HISTORIC AND DESIGN REVIEW COMMISSION

June 02, 2021

HDRC CASE NO: 2021-179
ADDRESS: 506 E PARK AVE
LEGAL DESCRIPTION: NCB 397 BLK 28 LOT 3 & E 1-2 OF 2
ZONING: RM-4, H
CITY COUNCIL DIST.: 1
DISTRICT: Tobin Hill Historic District
APPLICANT: Erin Camp/CAMP ERIN & COPPOLA KEVIN
OWNER: Erin Camp/CAMP ERIN & COPPOLA KEVIN
TYPE OF WORK: Driveway and front walkway modifications
APPLICATION RECEIVED: April 05, 2021
60-DAY REVIEW: Not applicable due to City Council Emergency Orders
CASE MANAGER: Rachel Rettaliata

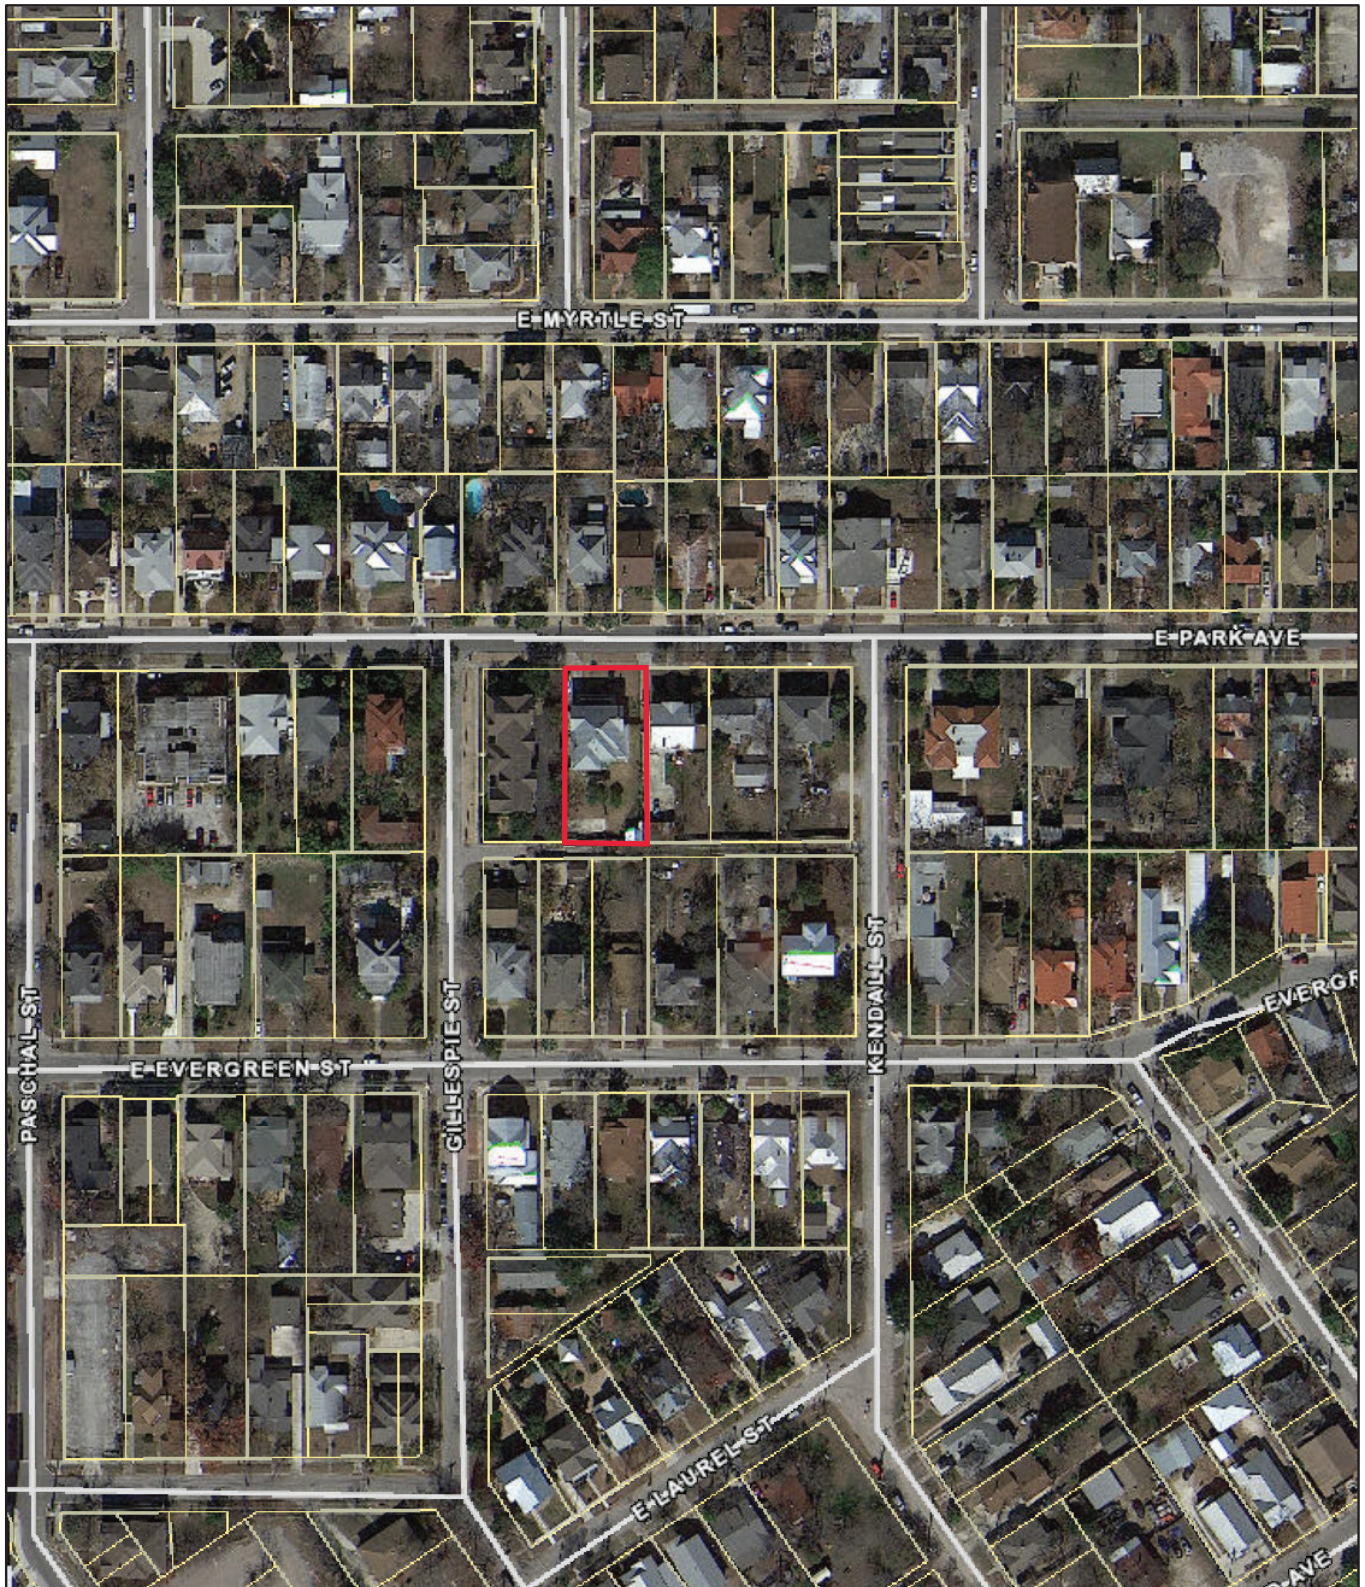
- d. **FRONT WALKWAY REPLACEMENT** – The applicant has proposed to replace the existing brick front walkway with rectangular concrete pavers. Guideline 5.A.i for Site Elements states that historic sidewalk and walkway paving materials—often brick or concrete—should be retained and repaired in place. According to Guideline 5.A.ii for Site Elements, when replacing those portions of sidewalks or walkways that are deteriorated beyond repair, every effort should be made to match existing sidewalk color and material. Guideline 5.A.iii states that replacement of walkways should follow the historic alignment, configuration, and width of walkways. Alter historic width or alignment only where absolutely necessary to accommodate the preservation of a significant tree. While properties immediately adjacent to 506 E Park also feature brick front walkways, the property may have originally featured a fully concrete front walkway. Staff finds the proposal inconsistent with the Guidelines. In-kind front walkway replacement or replacement with a fully concrete front walkway in the same footprint as existing is appropriate.

Item 2, staff does not recommend approval of the concrete paver installation based on finding c. Staff recommends that the applicant replaces the concrete pavers installed without approval with a brick or fully concrete walkway to match the previously existing footprint.
